ARROWHEAD RANCH INFRASTRUCTURE

BRIDGE AND CHANNEL IMPROVEMENT

UNION HILLS DRIVE AT SKUNK CREEK

ADDENDUM NO. 1
TO
ARROWHEAD RANCH INFRASTRUCTURE
BRIDGE AND CHANNEL IMPROVEMENT
UNION HILLS DRIVE AT SKUNK CREEK

UTILITY LOCATION DETAIL
UNION HILLS DRIVE BRIDGE,
APPROX. SCALE 1" = 40'

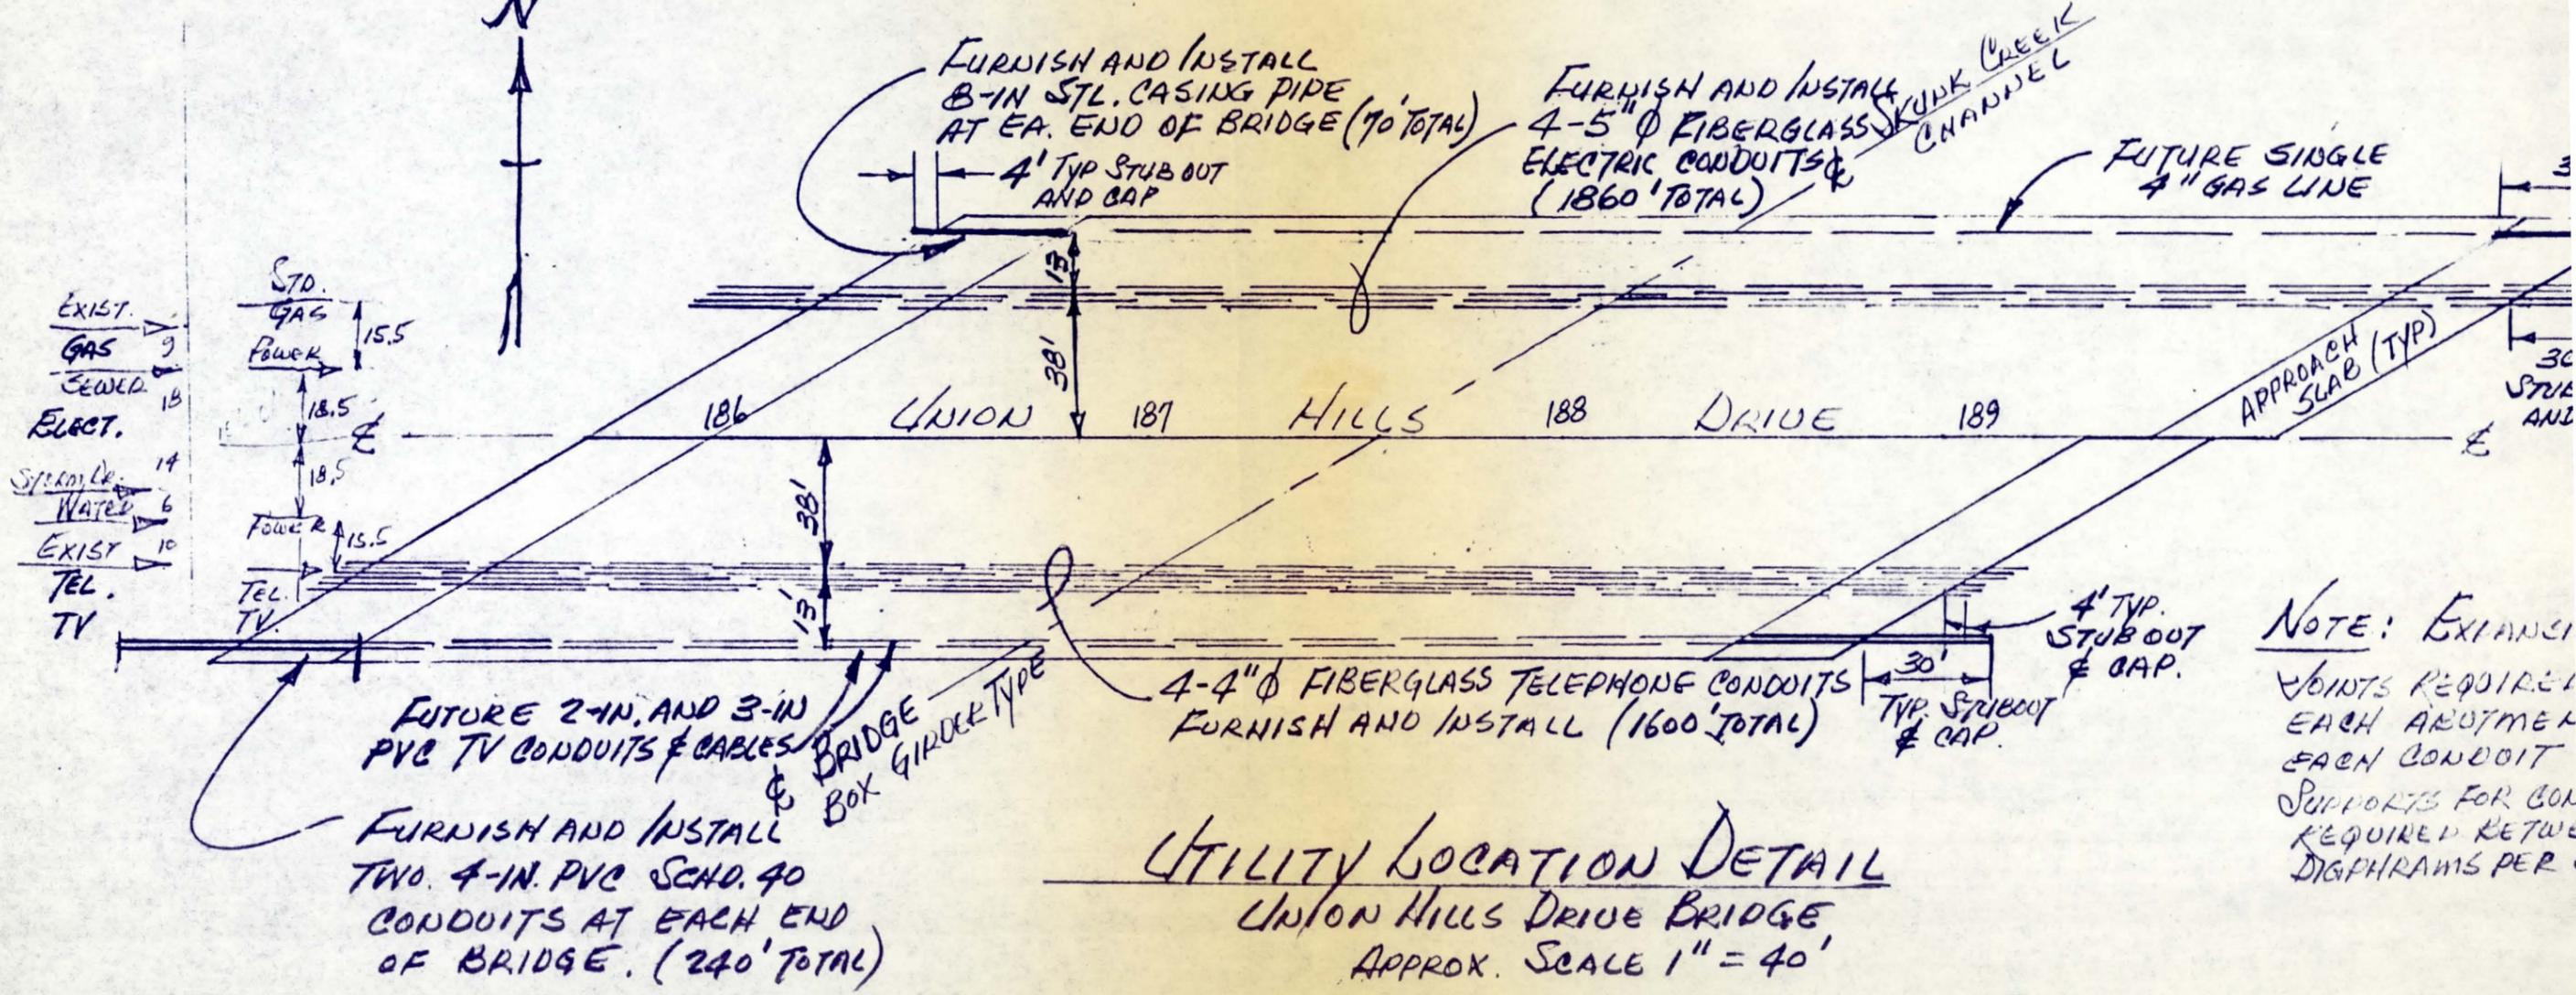
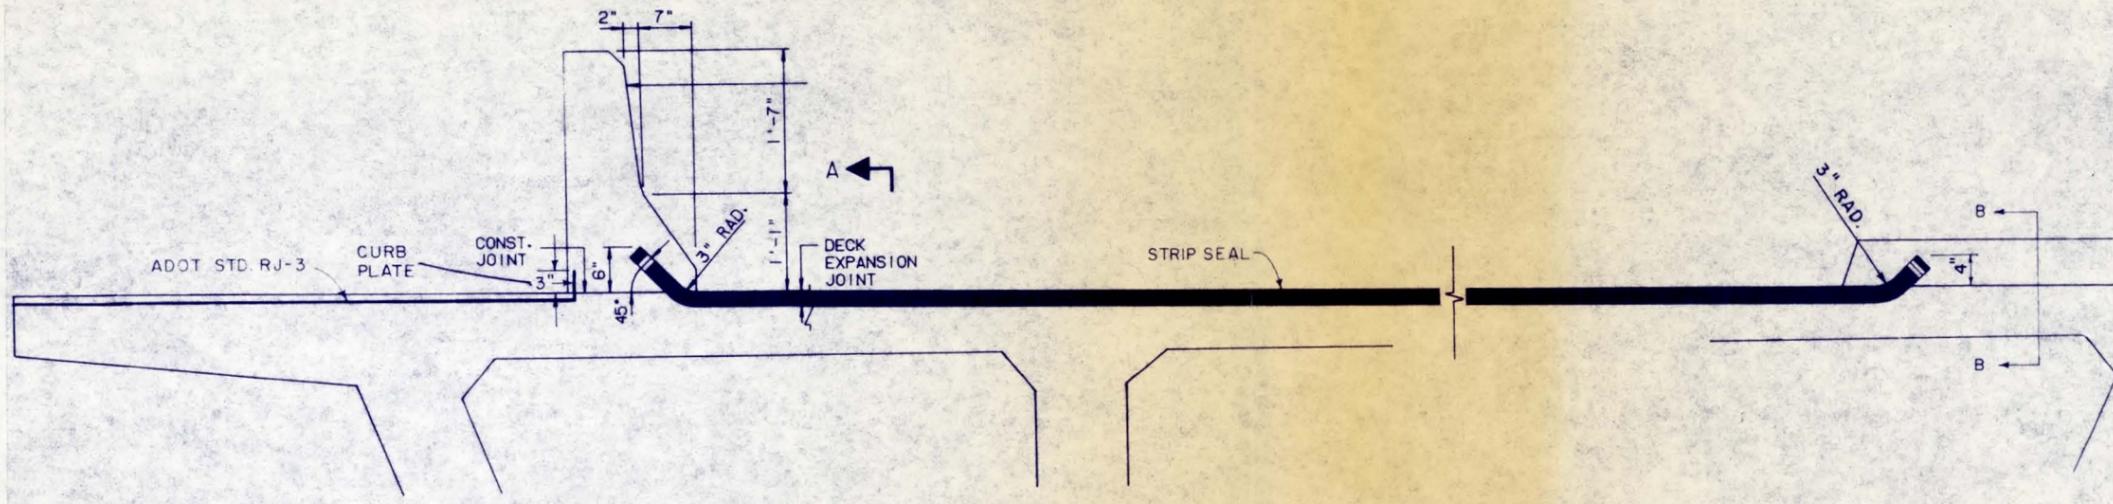
Relative to the Bridge Plan Sheets 8 to 24, utility conduits are to be installed through the bridge and abutments in accordance with the Special Provisions and installation details to be provided during construction at the locations indicated in the Utility Location Detail sketch and Alternate Fiberglass Duct Installation Detail attached to this Addendum.

SECTION B-B
MEDIAN JOINT

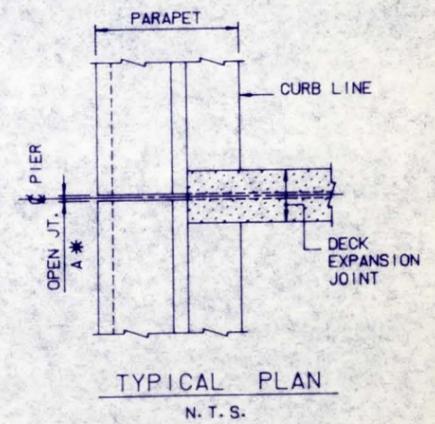
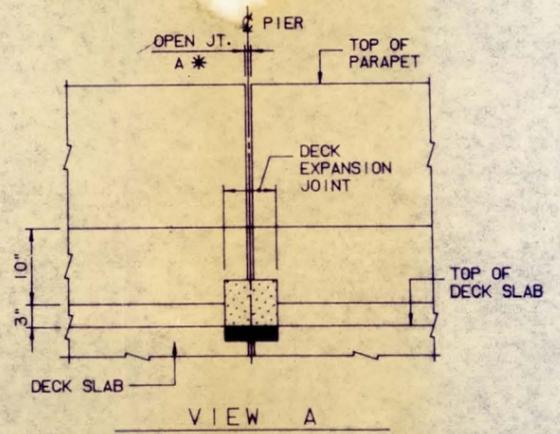
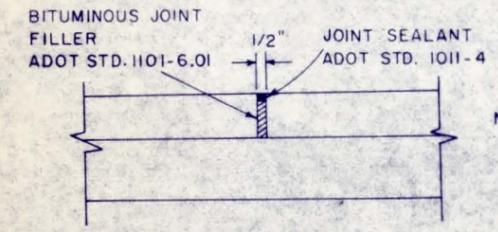
Transverse joints shall be included in the raised median at 20-foot centers as detailed on the plans.

On Sheet 8 under Construction Details and on Sheet 13, Section C-C, the expansion joint shall be of waterproof strip seal type across the street and ADOT Std. RJ-3 across the sidewalks. The median joint may remain open. Transverse joints in the raised median shall be at 20 foot intervals. Acceptable deck joint assembly manufacturers are listed on a separate page attached to this Addendum. Installation of weatherproof strip seal and RJ-3 at sidewalks are detailed on the detail of Deck Joints attached to this Addendum.
